APPEAL SUMMARY

Appeal ID: 20421	Project Address: 2510 NE Sandy Blvd
Hearing Date: 5/22/19	Appellant Name: Shea Gilligan
Case No.: B-008	Appellant Phone: 6462630186
Appeal Type: Building	Plans Examiner/Inspector: Geoffrey Harker
Project Type: commercial	Stories: 5 Occupancy: R-2, M Construction Type: III-B
Building/Business Name: Atomic Orchard	Fire Sprinklers: Yes - throughout
Appeal Involves: Reconsideration of appeal	LUR or Permit Application No.:
Plan Submitted Option: pdf [File 1] [File 2] [File 3] [File 4] [File 5] [File 6]	Proposed use: Mixed Use

APPEAL INFORMATION SHEET

APPEAL DECISION

Exhibit 1

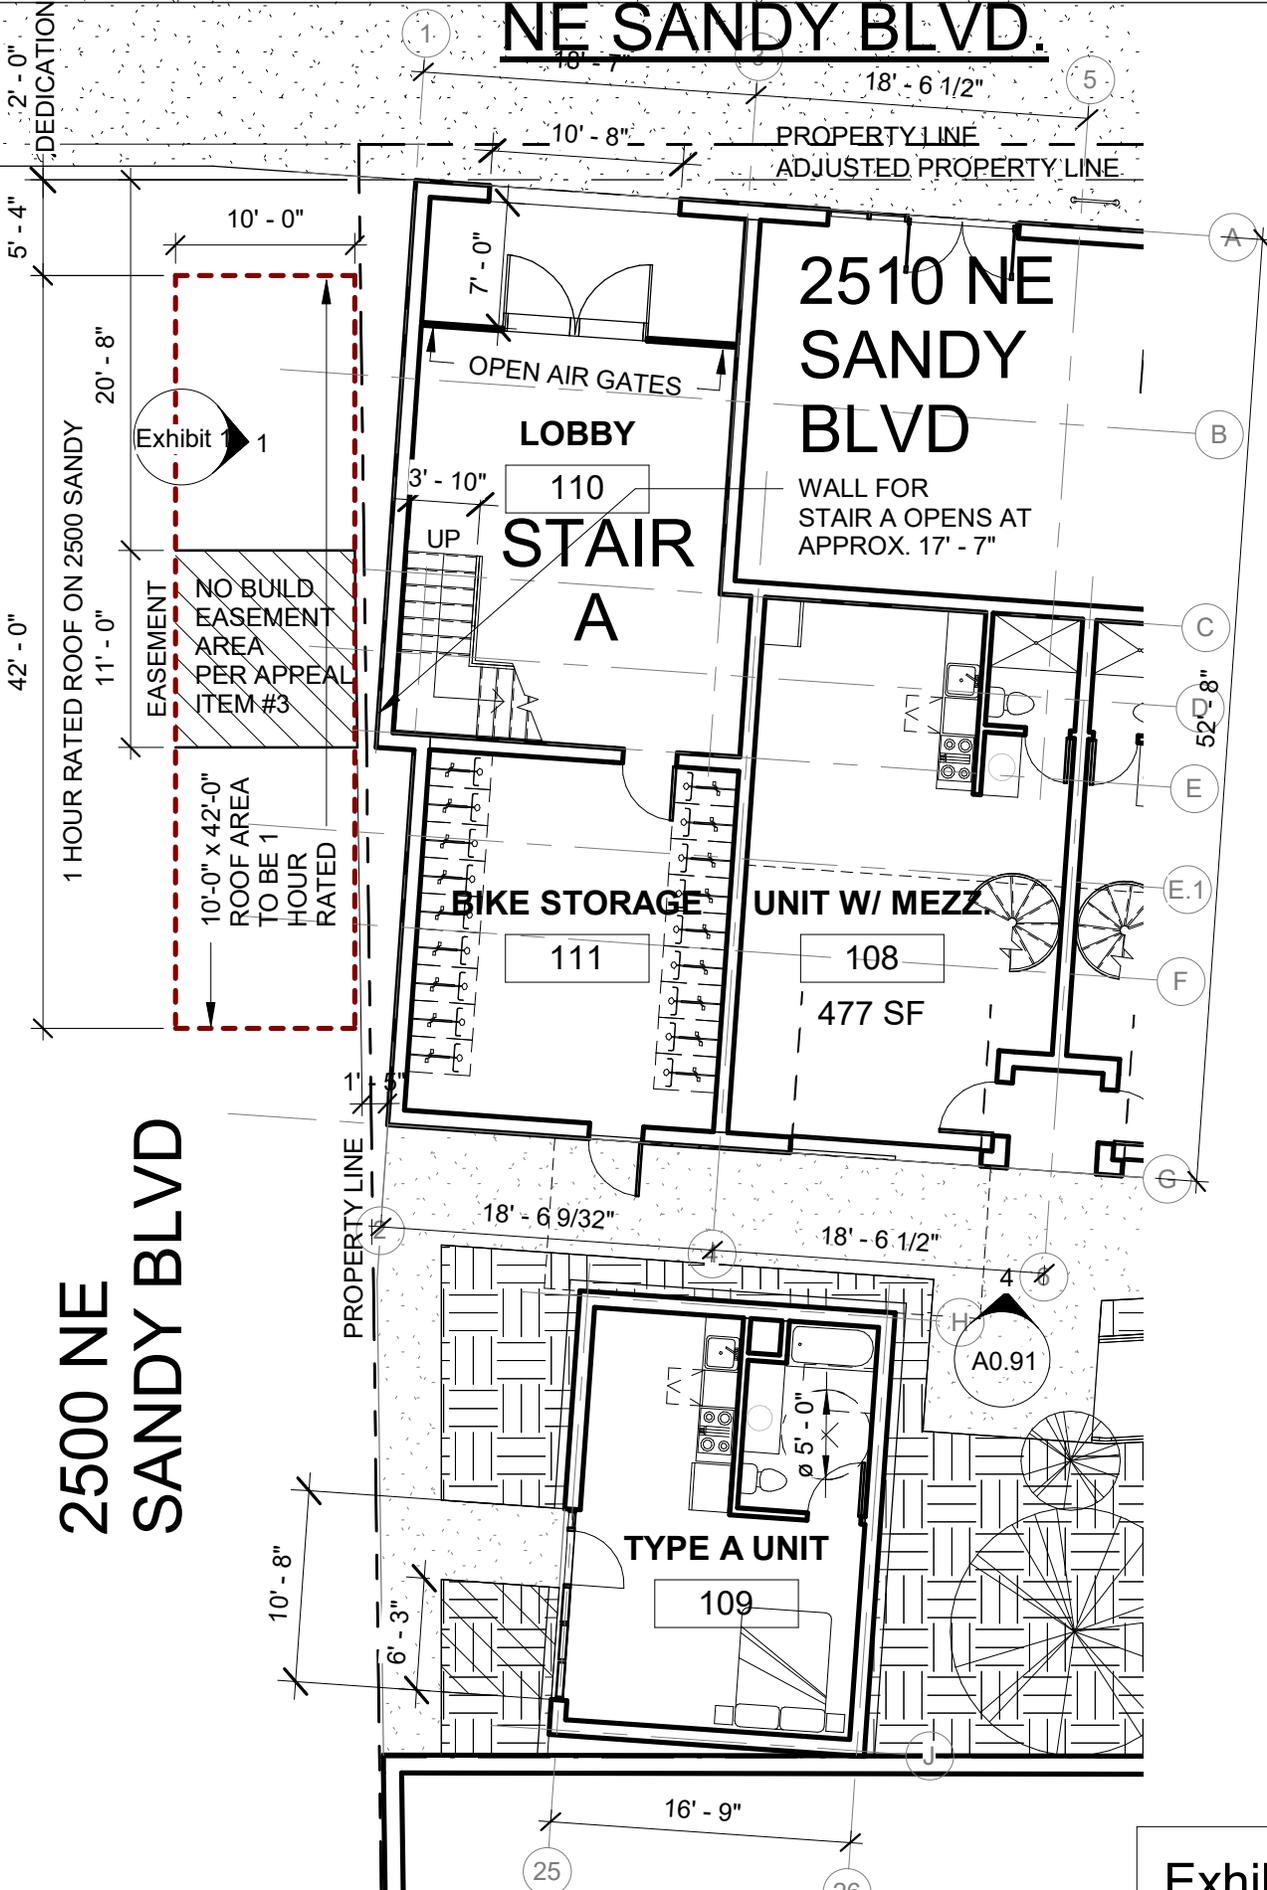
Proposed Design The west elevation of this site, 2510 NE Sandy, shows exterior exit stair, Stair A, of which a 9'-0" wide x 15'-0" high portion is located within 15' vertically above the roof of the existing building. There are 2 overhead doors also within this zone. (see Exhibit 1 for the west elevation and Exhibit 2 for a partial site plan showing the two adjacent properties).

1. One hour fire rated roof construction of existing lower building in buildings with vertical exposure on separate lots: Granted provided the building permit for the 1 hour fire resistance rating of the roof structure is finalized prior to the issuance of the Certificate of Occupancy for the proposed building.

Exhibit 2
Scale 3/32" = 1'-0"

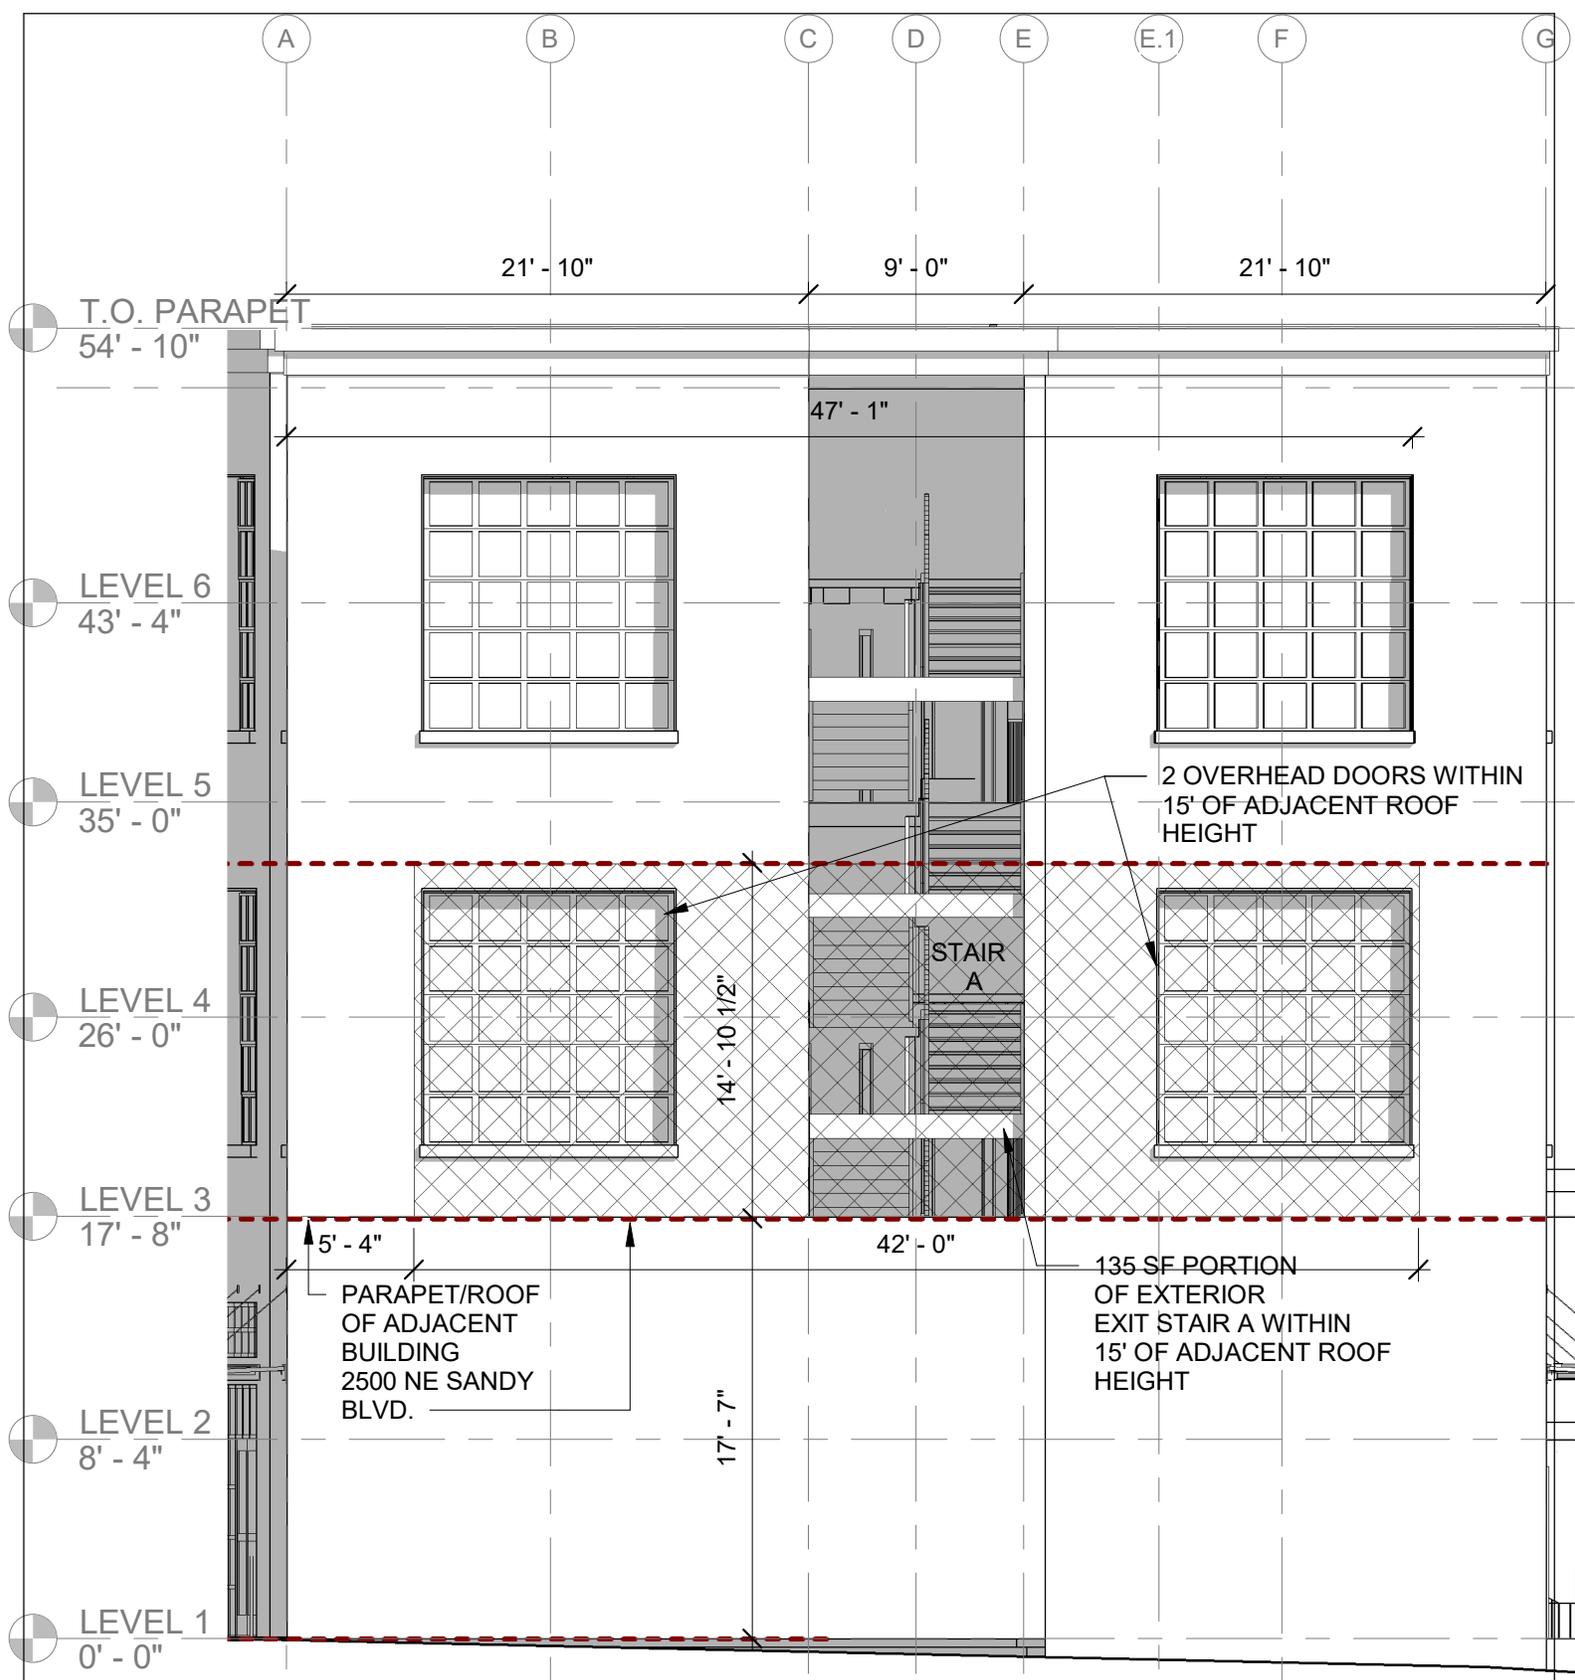
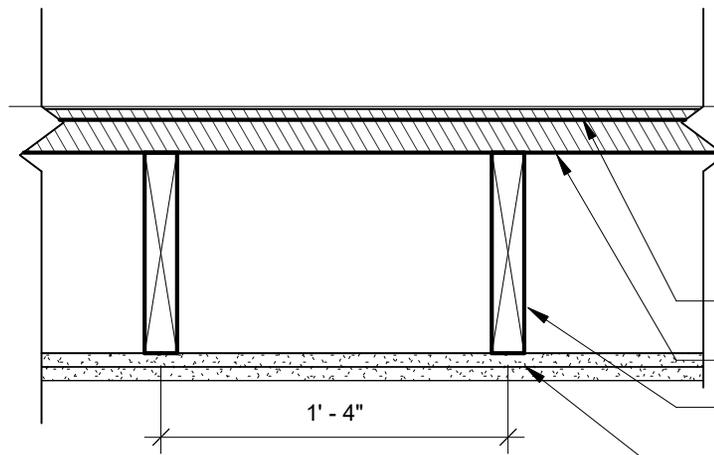
There is an existing one story building at 2500 NE Sandy Blvd., which is built to the property line in all directions. Appellant proposes that 2500 NE Sandy is treated as the "new" building, since it is owned by the same owner as 2510 NE Sandy and therefore can be modified to be code compliant. Appellant proposes that all of the roof area which is within 15' of 2510 NE Sandy Blvd. be modified to have a 1 hour roof construction (see Exhibit 3 for the one hour detail and Exhibit 4 for the roof plan for 2500 NE Sandy Blvd). This roof area on the 2500 NE Sandy Blvd. project includes an area 42"(north-south) x 10'-0" (east west) from the 2510 NE Sandy Blvd. north property line. Heavy timber beams and columns, and concrete pilasters in the 2500 NE Sandy Blvd. site meet 1 hour rating equivalency per char calculations for this area of the roof. (Exhibit 5)

Reconsideration Text: A survey has been added showing the two adjacent site plans, with the 1 hour roof portion of the 2500 NE Sandy Blvd. site identified.

Proposed Design The west stair (Stair A) is located within 10' of the property line, however the adjacent lot is owned by the same owner as this site. The adjacent property to the west, 2500 NE Sandy Blvd, is a one story building with an existing two hour wall next to Stair A. This 2 hour concrete wall will provide protection for the exterior stair below the roof line of the adjacent building. A no-build easement is proposed above the roof of the adjacent building to provide the required 10 foot separation above the roof of 2500 NE Sandy Blvd. (see Exhibit 2). Stair A is additionally protected by the 1 hour roof assembly proposed in Appeal Item 1.

2. Exterior exit stair with less than 10 feet of fire separation distance and no build easement: Granted provided the easement is a minimum of 10 feet wide.

The easement must include language that establishes the edge of the easement on the adjacent lot as the implied property line for the purpose of determining fire separation distance for future development on the adjacent lot.
